Water pump replacement 65465 by 65467 requires change of camshaft pulley

Technical info no. 2110

Volkswagen: Van T4

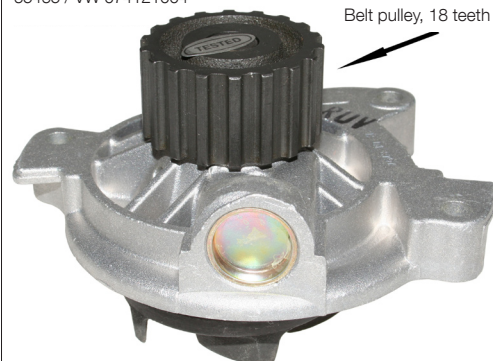
When replacing the water pump with an 18 tooth belt pulley (65465) by the new 20 tooth profile (65467), the camshaft pulley must also be replaced.
Original part number: 023 109 111 D

The toothed belt is difficult to mount.

Ruville recommends that all belt drive components be exchanged, when the belt-driven water pump is replaced.
